MAJESTIC COMMERCENTER - PROJECT FRONTIER

SITE PLAN

MAJESTIC COMMERCENTER PROJECT
FRONTIER - SITE PLAN
GENERAL NOTES

PROJ NO: 240428
ENG: EAP/JLE
DATE: 12/11/2024

SHEET DESCRIPTION
L-2
SHEET 9

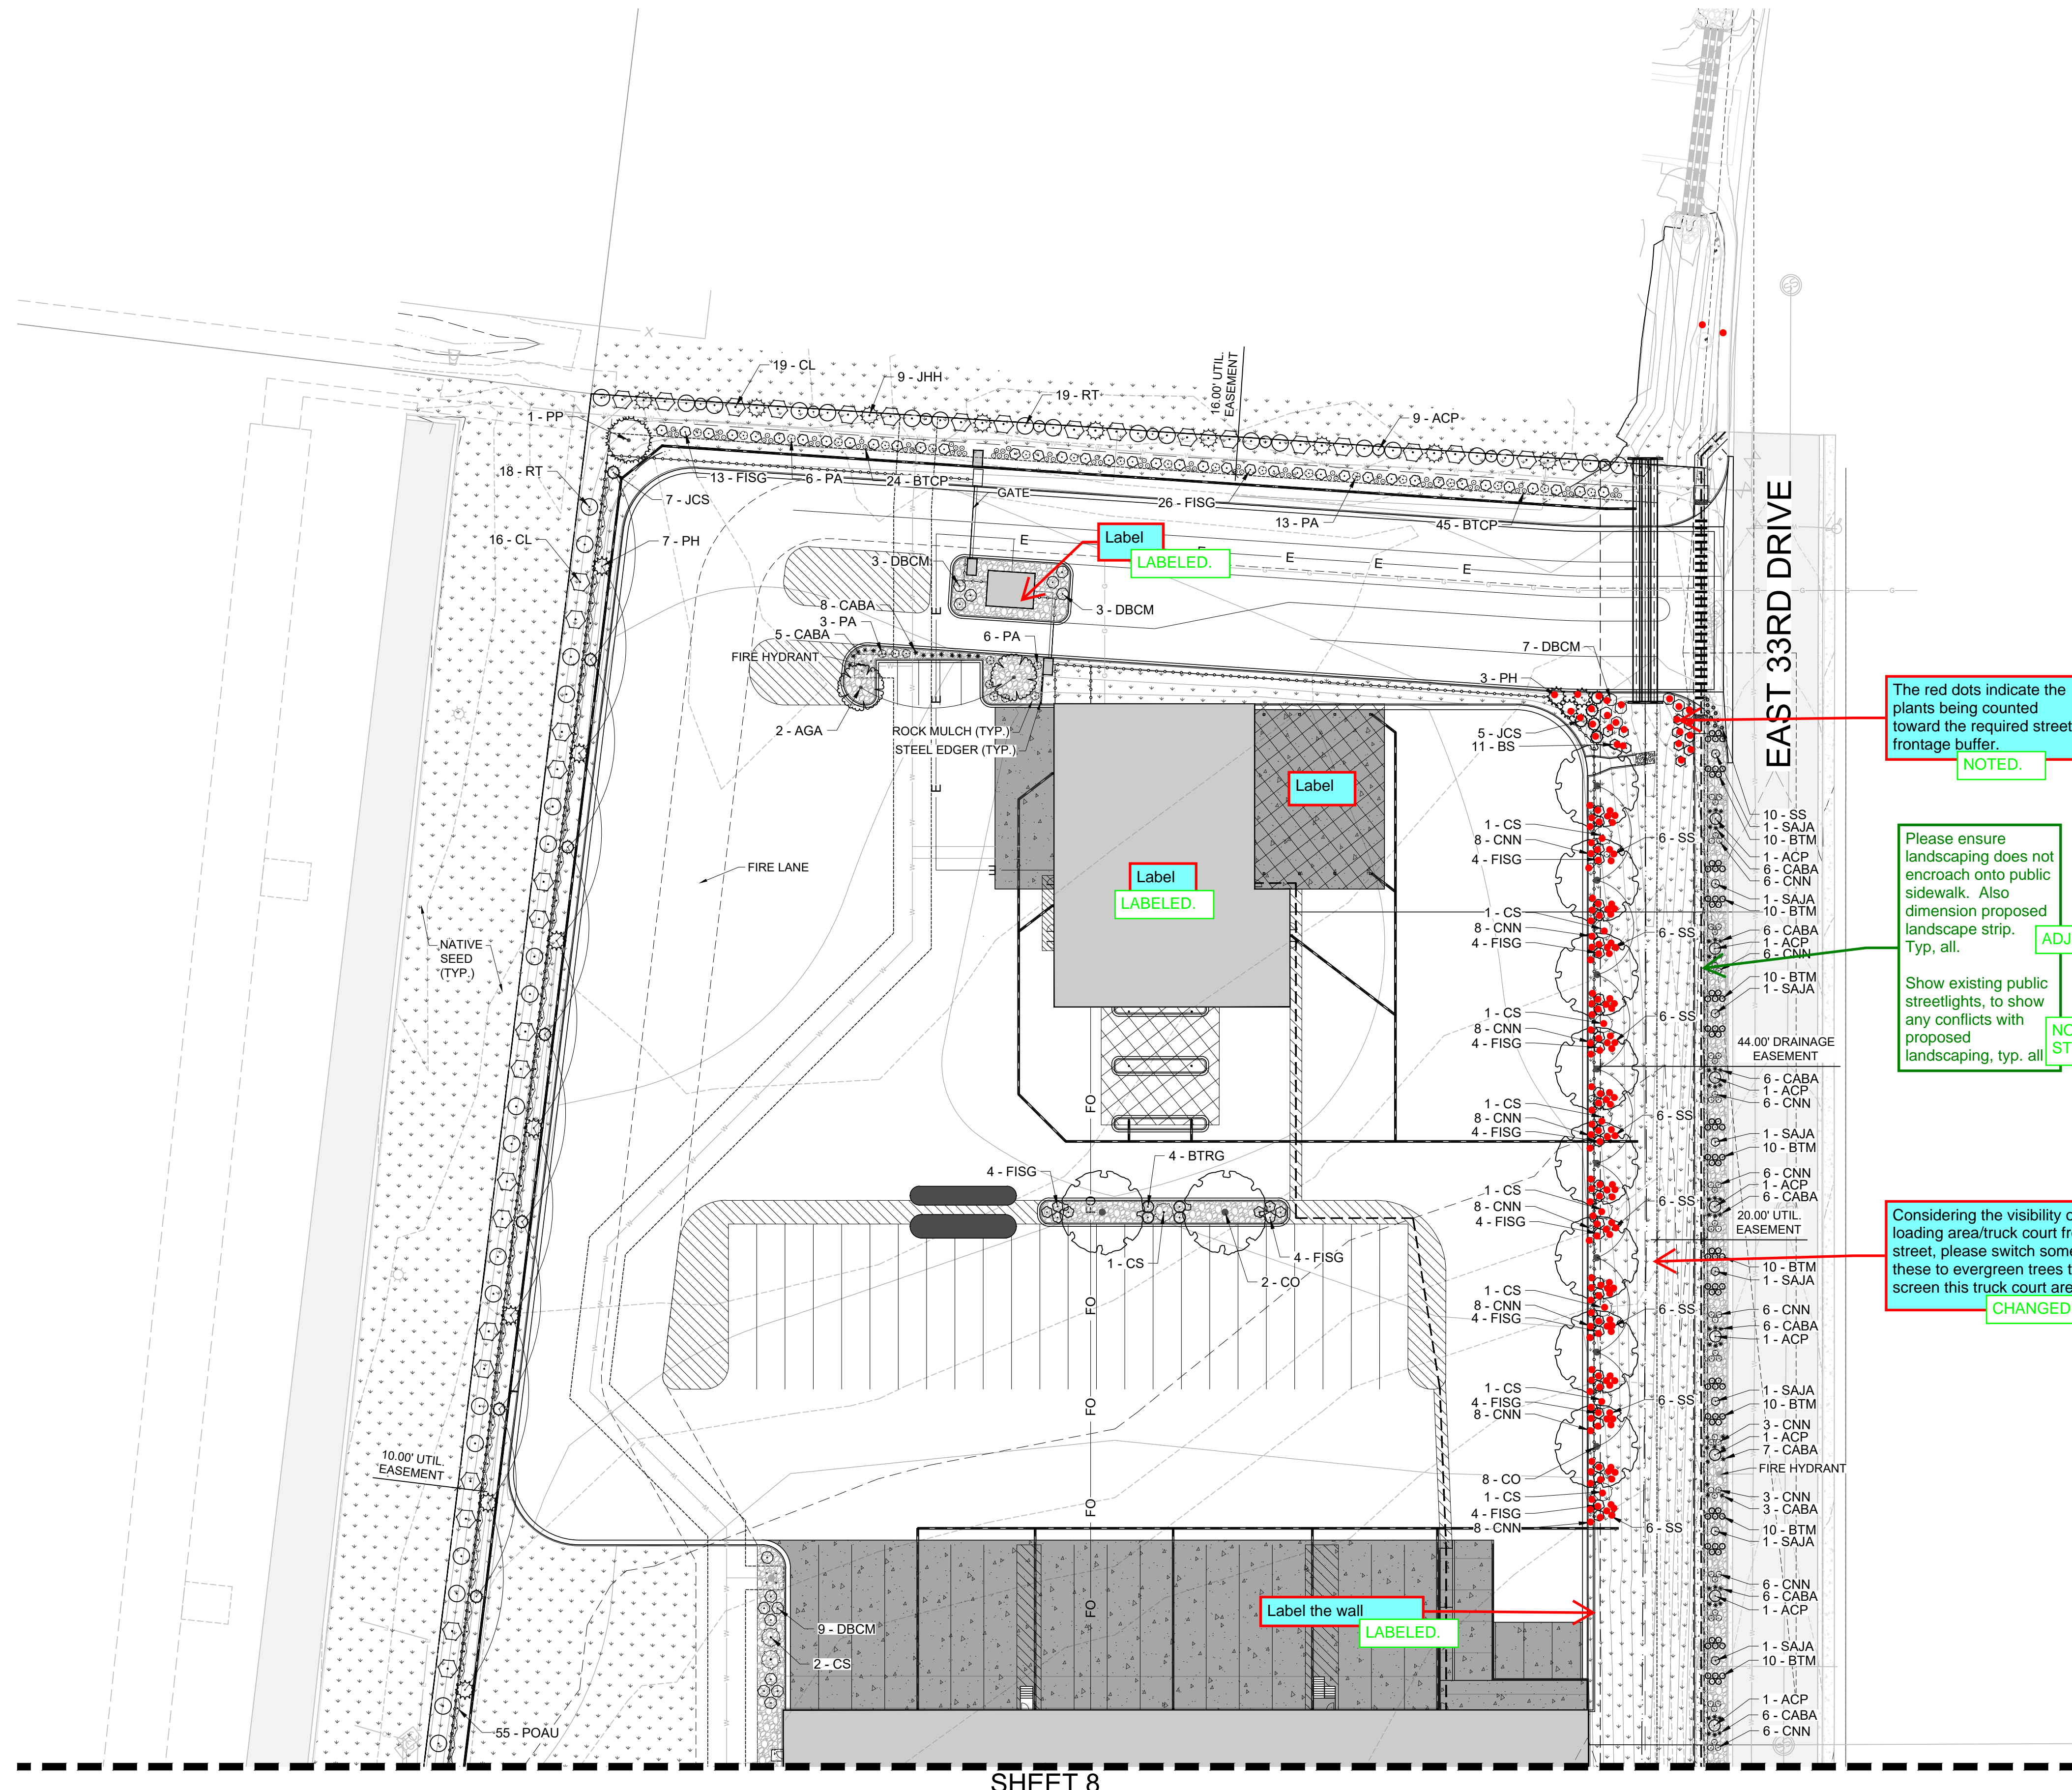
The red dots indicate the plants being counted toward the required street frontage buffer.
NOTED.

Please ensure landscaping does not encroach onto public sidewalk. Also dimension proposed landscape strip.
Typ, all.
ADJUSTED.

Show existing public streetlights, to show any conflicts with proposed landscaping, typ. all
NO EXISTING STREETLIGHTS.

Considering the visibility of the loading area/truck court from the street, please switch some of these to evergreen trees to help screen this truck court area.
CHANGED.

ADD NOTE:
All proposed landscaping within the sight triangle shall be in compliance with COA Roadway Specifications, Section 4.04.2.10

NOTE ADDED TO GENERAL NOTES ON SHEET D-1.

A300

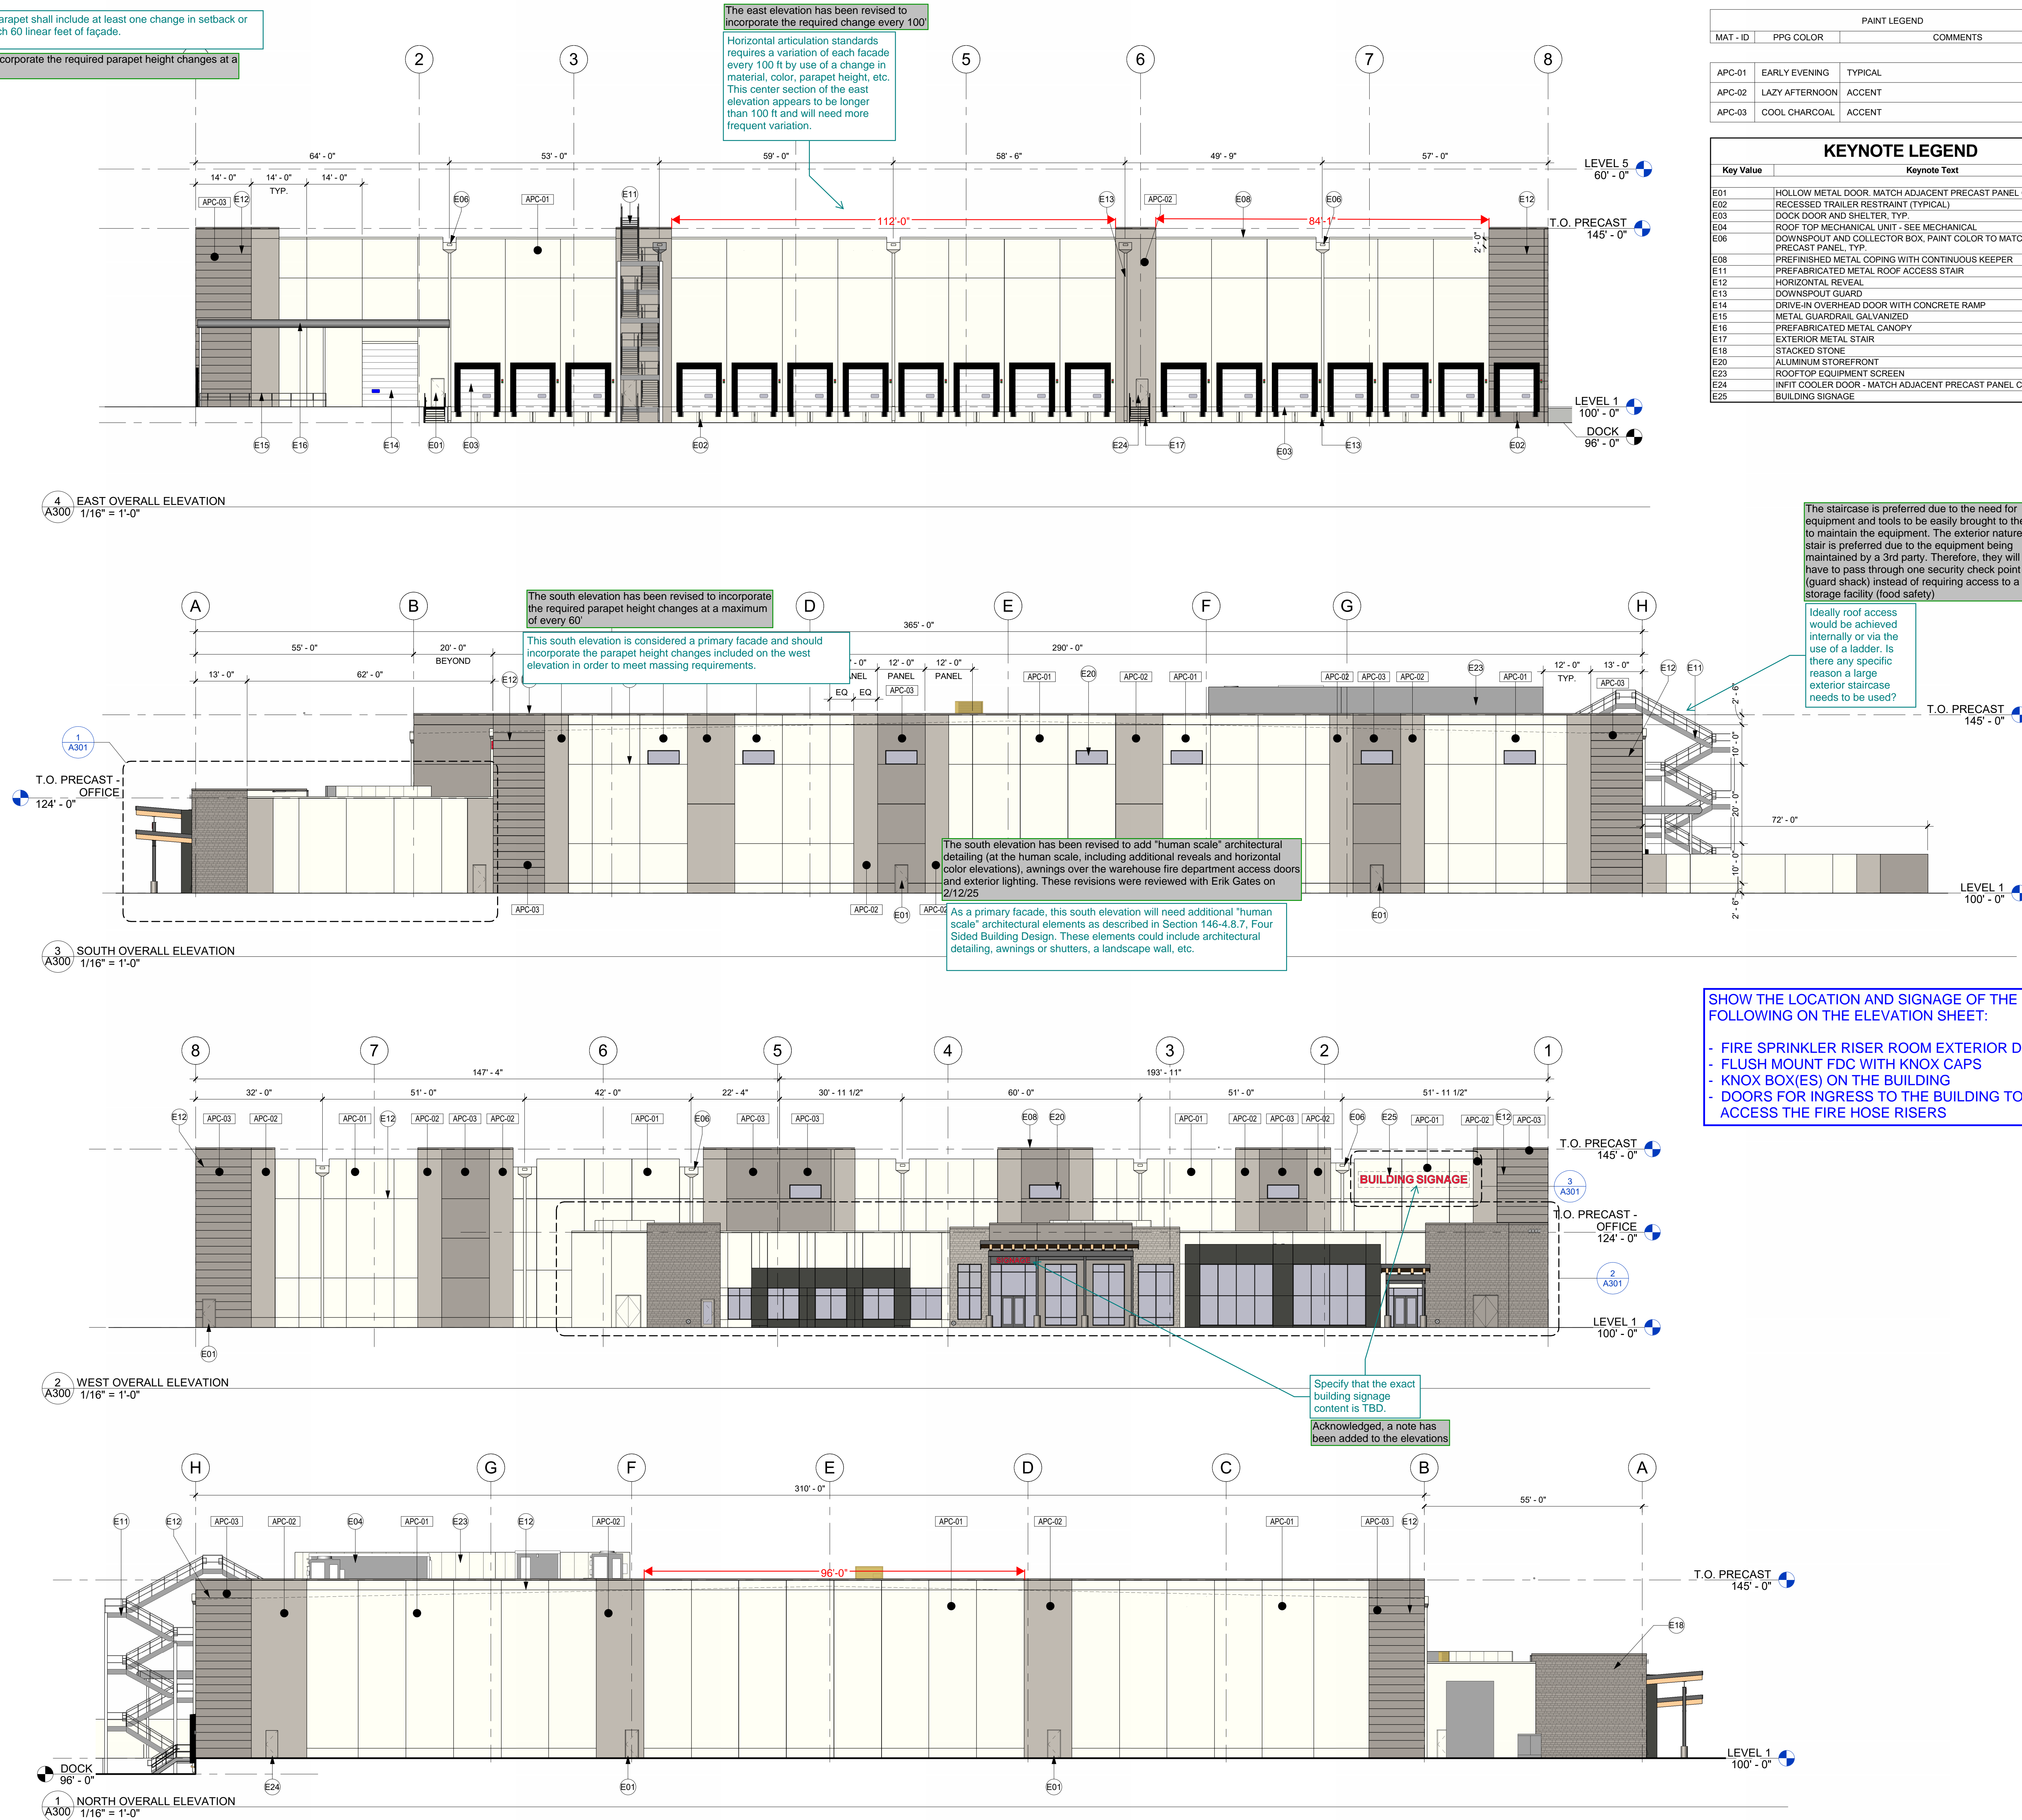
Horizontal articulation standards requires a variation of each facade every 100 ft by use of a change in material, color, parapet height, etc. This center section of the east elevation appears to be longer than 100 ft and will need more frequent variation.

All elevations have been revised to incorporate the required parapet height changes at a maximum of every 60'

1 VMB SOUTH ELEVATION
A302 3/32" = 1'-0"

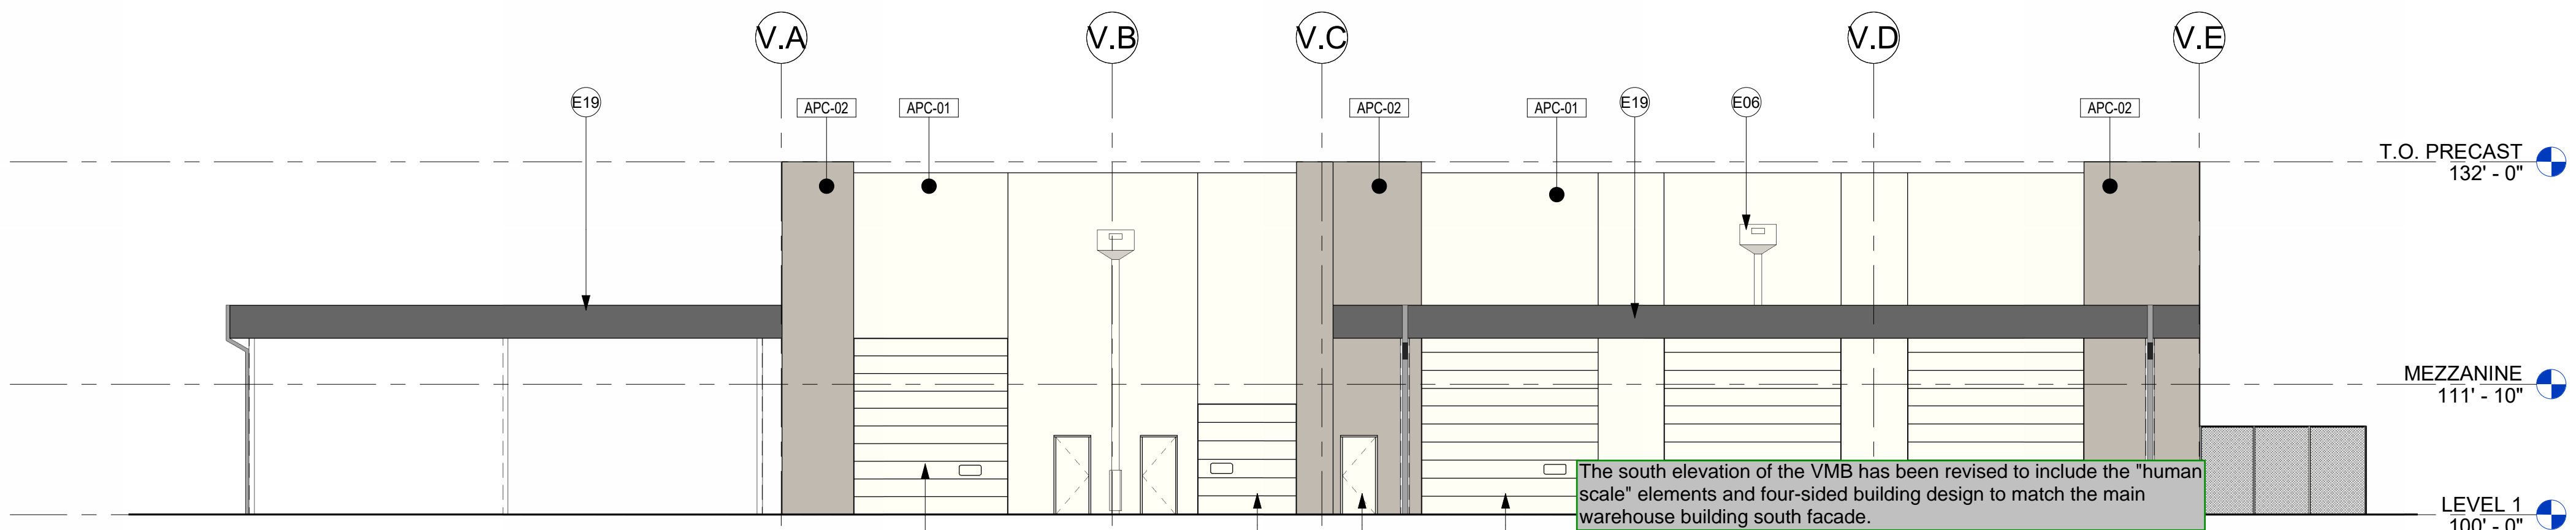
SHOW THE LOCATION AND SIGNAGE OF THE FOLLOWING ON THE ELEVATION SHEET:

- FIRE SPRINKLER RISER ROOM EXTERIOR DOOR
- FLUSH MOUNT FDC WITH KNOX CAPS
- KNOX BOX(ES) ON THE BUILDING
- E-STOP FOR THE FUEL PUMPS

This south elevation will be considered a primary facade for the vmb, and will need additional massing, materials, and "human scale" architectural elements as described in Section 146-4.8.7, Four Sided Building Design. The massing element could include, but are not limited to, a wall offset (min. 3ft) or wall notch (min. 12in). The material element could include a change in facade material, texture, or the use of a variety of window sizes. Two more human scale elements are needed and could include architectural detailing, building mounted lighting, or building corner enhancements.

Acknowledged and shown on elevations

The south elevation of the VMB has been revised to include the "human scale" elements and four-sided building design to match the main warehouse building south facade.
